## COMMITTEE REPORT

**Application No.:** 172192/PNN

**Address:** Reading West Station Footbridge, Oxford Road, Reading.

**Proposal:** Prior Approval under Part 18 Class A to Schedule 2 of the Town and Country Planning (General Permitted Development) (England) Order 2015 (the GPDO) for reconstruction of the footbridge to provide the necessary clearance for the OLE which is to run underneath the structure.

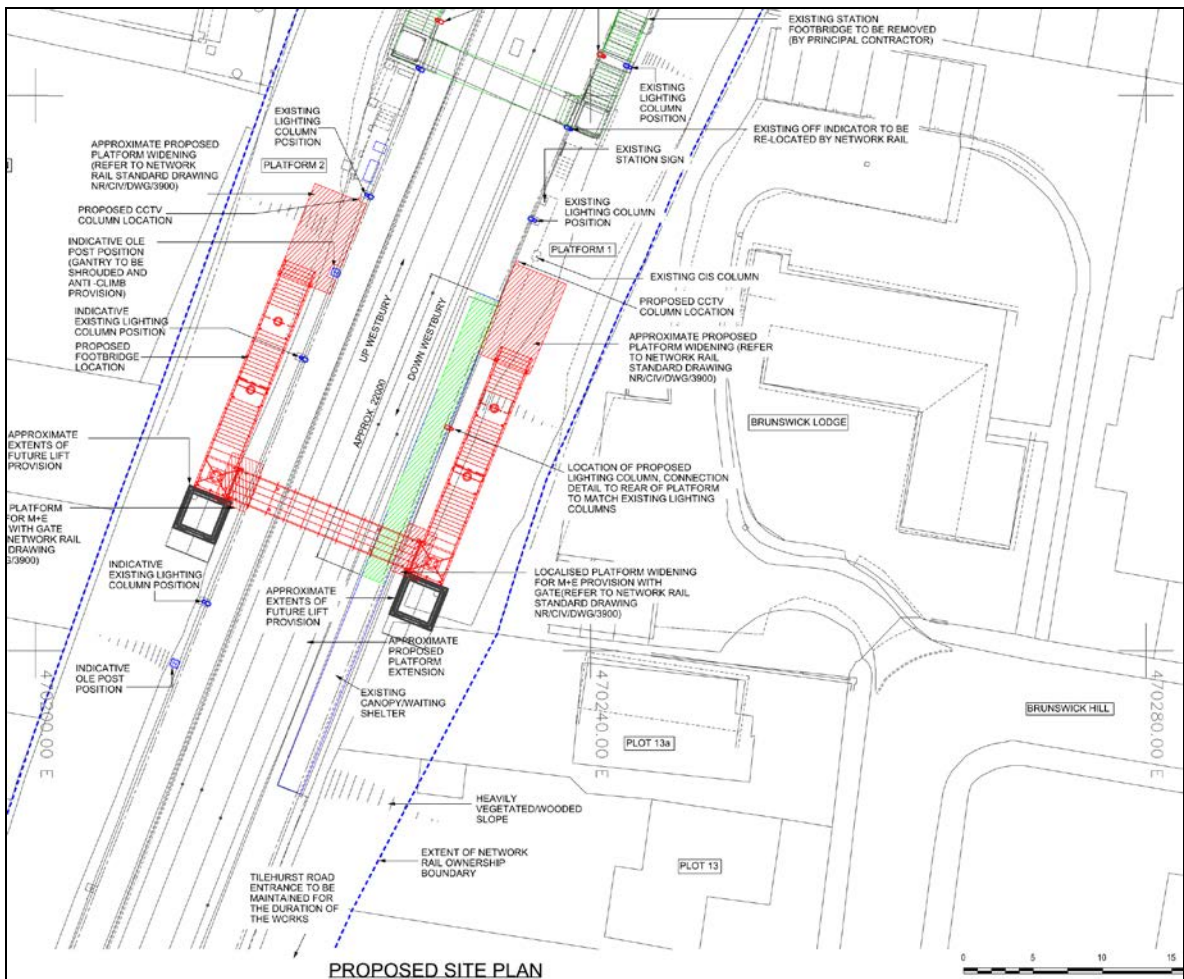
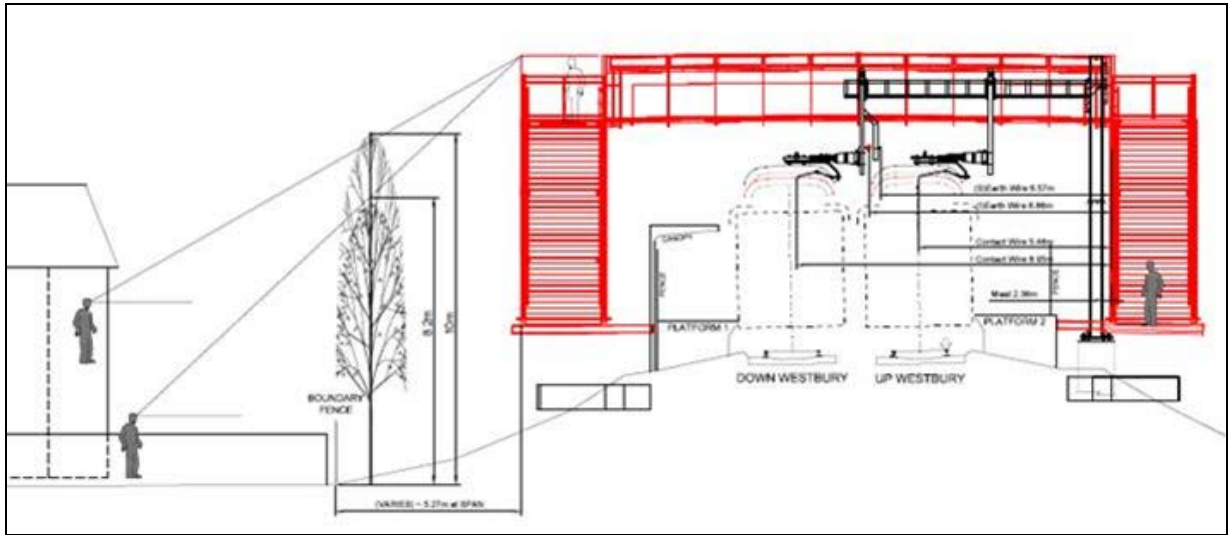
- 6.3 The current proposal, by contrast, would sit close to the rear (habitable room) windows and garden of 13A Brunswick Hill, at a distance of approximately 12.5 metres from the rear of the house and close to the north-west corner of the property boundary. Having visited the site it is considered that the scale of the bridge, its proximity to number 13A, and its elevated position relative to this neighbour, would result in a stark dominant and overbearing structure that would harm the amenity of 13A Brunswick Hill in particular. The 'future lift provision', if provided, would further add to this harm due to its bulk and position which would extend further across the rear of the neighbouring plot.

- 6.9 The Applicant has provided a diagram, copied below, which indicates the relationship between the proposed bridge and the rear of 13A Brunswick Hill and is considered to demonstrate the detrimental impact on this neighbour quite effectively. The top of the tree (suggested by the Applicant as mitigation - not existing currently) is labelled as being 10 metres above the ground level of the neighbouring garden, the bridge is shown higher than this at around 12 metres above the neighbouring land. The second drawing below (site plan) shows the relationship between the structure and 13A in the horizontal plane.

Proposed Side Elevations (revised 17/5/18 to show privacy screens)

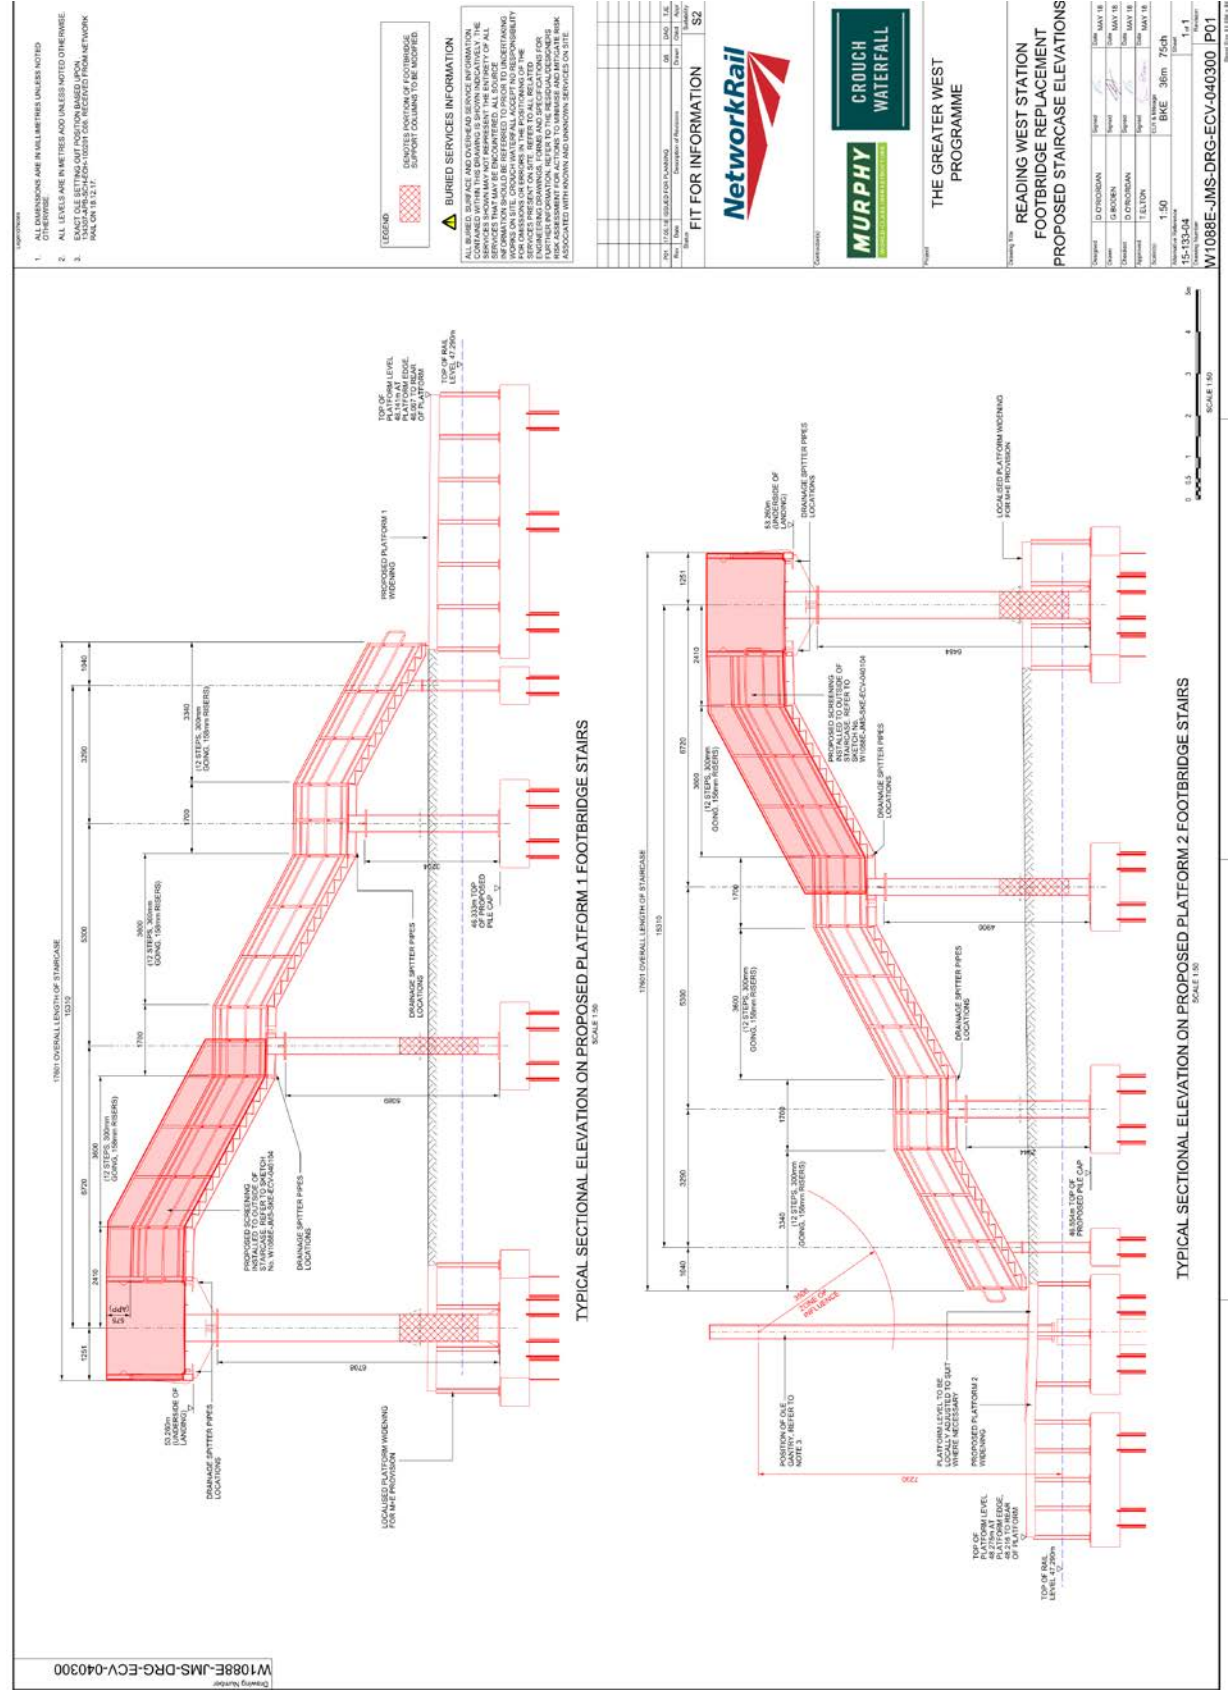
- 6.4 The proposed privacy screening (the Applicant has clarified that this would comprise solid steel panels 1.8m above the surface of the steps as shown on the revised drawings), whilst welcome in general terms, would add to the apparent scale and overbearing nature of the proposal in the proposed location. It is also considered that the screen in itself would not be sufficient to prevent harm to the amenity of the neighbouring dwelling due to the perception or awareness of bridge users passing high above the garden at close quarters with associated privacy implications. It is therefore considered that, whilst adequate modification could be made to the design to prevent intervisibility and direct overlooking to neighbours, the '*siting*' remains a fundamental concern in terms of the impact on the amenity of neighbouring dwellings and 13A Brunswick Hill in particular.

- **Details of the privacy screening from the bridge and steps** – we have previously submitted this to be shown on the top section of steps to stop overlooking. However contrary to discussions at our meeting when we suggested the privacy screen would be perforated we can provide this with a solid screen in a similar manner to that which we propose across the bridge span. The privacy screen would be 1.8m in height from the step surface and by being solid in structure would stop all overlooking. The photo below shows how the parapet would appear 1.8m tall across the bridge span which would ensure there was no overlooking from here.
